PERMIT MODIFICATION APPROVAL

Re: Permit Modification Approval for API Number 10302906, Well #: 513982
Modify depth of 13-3/8" and 9-5/8" casing

Re: Casing on Well 513982 (PNG103)

Well Schematic
EQT Production

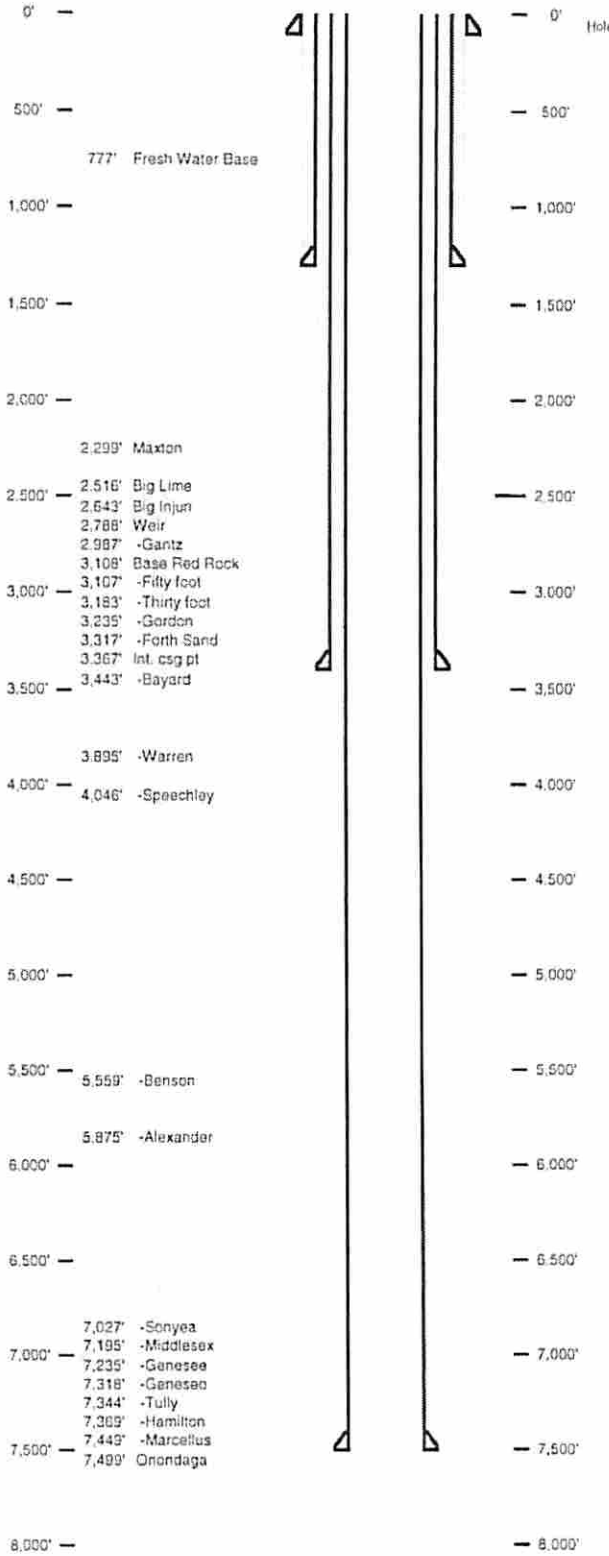
EQT is requesting the 13-3/8" surface casing be set at 1299' KB, 50' below the red rock base at 1249' without setting below elevation. The previous wells drilled on this pad set 13-3/8" casing at approximately 850' KB. This will cover up red rock formations that have given EQT drilling issues in the past. We will set the 9-5/8" intermediate string at 3367' KB, 50' below the base of the Gordon formation.

TOC @ Surface
13 3/8", MC-50, 54.5# @ 1,299 ft MD
Bit Size 12.375"

TOC @ Surface
9 5/8", MC-50, 40# @ 3,367 ft MD
Bit Size 8.5"
